Review of Plans: Fisher Site Plan, 7 Berachah Avenue, South Nyack, NY
Section 66.61 Block 1 Lot 19-2 R-12HC zone

Subject: **Fisher Site Plan**
7 Berachah Avenue, South Nyack
Section 66.61, Block 1, Lot 19.2, R-12HC zoning district

Final Subdivision Plan as prepared by Lawler, Matusky & Skelly Engineers, LLP, signed by South Nyack Planning Board Chair, 6-22-2005 Site Plan as prepared by Sparaco & Youngblood PLLC, last revised 2/26/2024 and Architectural Plans as prepared by Kier B. Levesque, RA, last revised 2/23/2024.

PB #23-04: Fisher Site Plan
Critical Environmental Area-South Nyack
Preliminary Site Plan Approval Subject to Conditions
Neg. Dec.

KIER B. LEVESQUE, R.A.
ARCHITECT
49 THIRD AVENUE
NYACK, NEW YORK 10960
845-358-2359

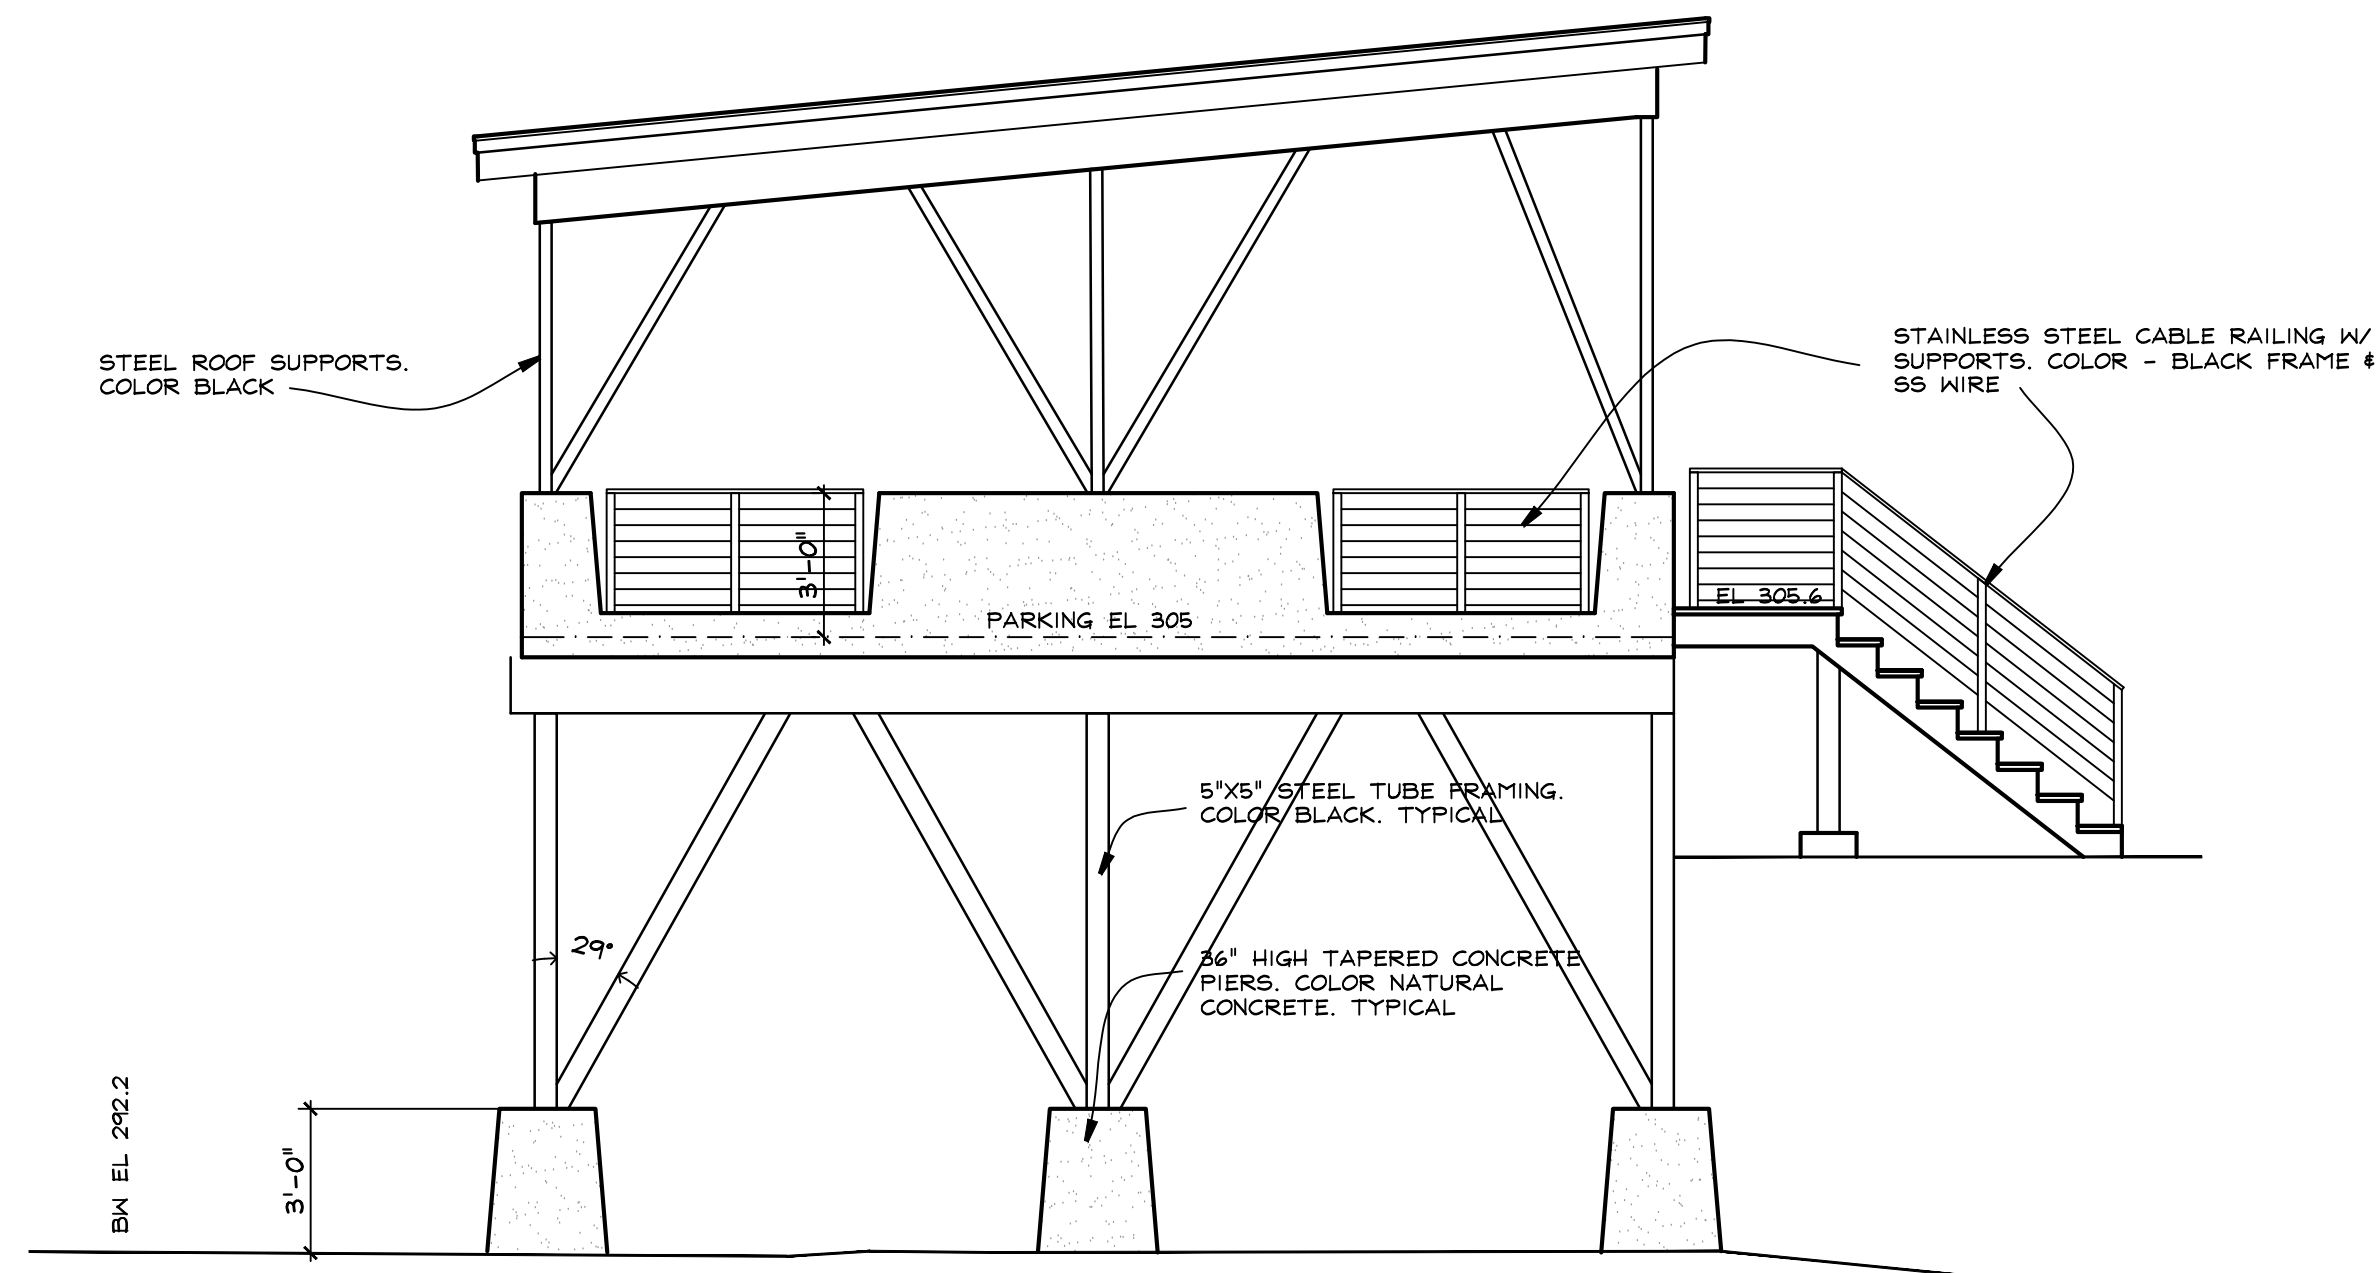
- 2) Per RG-8 Zoning district chart on page 7 of the subdivision plan the following variances are required;
 - a) front yard setback to carport is 4 feet, with 55 feet required to accessory structures.

- b) proposed carport is 505 square feet which results in a lot coverage of 10.6% with 7% required for accessory structures.
 - c) Maximum lot coverage permitted is 45% with 55% proposed.

- 4) Per Chapter 43, Article XVIII (18), section 18.35, “*Maximum building height applicability. In considering maximum height per Hamlet of South Nyack General Use, Bulk and Parking Regulations, per Figure 1, when considering a front yard setback variance for any structure, allowable roof height to the topmost extremity shall not extend above a line drawn from 5 1/2 feet above the nearest point on the front lot line to a point 30 feet above the required front yard setback. An exception to this limit may be granted only if there is no other feasible alternative and if the balancing of benefits to the applicant if granted, versus benefits to the community if not granted, weigh strongly in favor of the applicant.*” Variance required as a portion of the carport roof is outside of the envelope, see sketch.
- 5) College Avenue is a private road, a 280-A Variance is required.

INLET/OUTLET MANHOLE #2

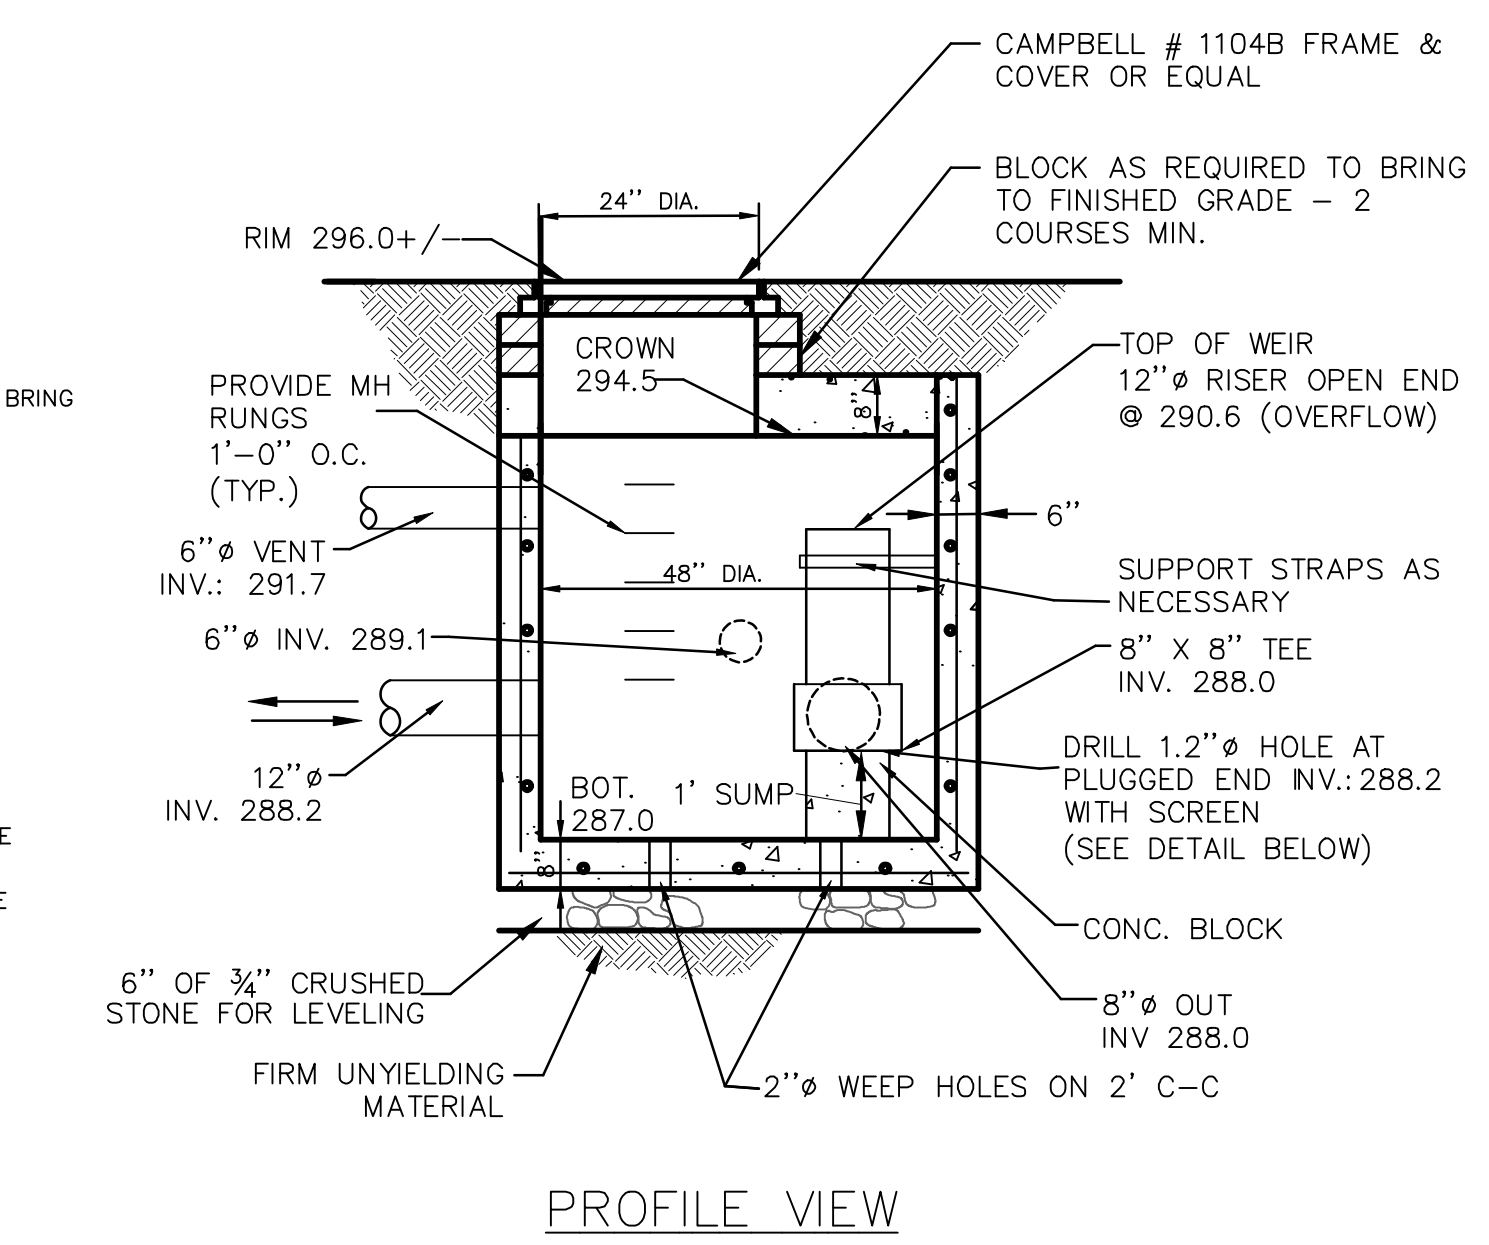
19. Sheets 2 & 3 label the "P Storm inlet/ outlet" manhole as #4. However, the detail for same on sheet 5 labels it as manhole #2. The labels shall be coordinated.

1. As per the July 11, 2023 drainage review, change the label on "Inlet/Outlet Manhole #2" on the Detail Sheet to "Inlet/Outlet Manhole #5 to match the Grading Plan.
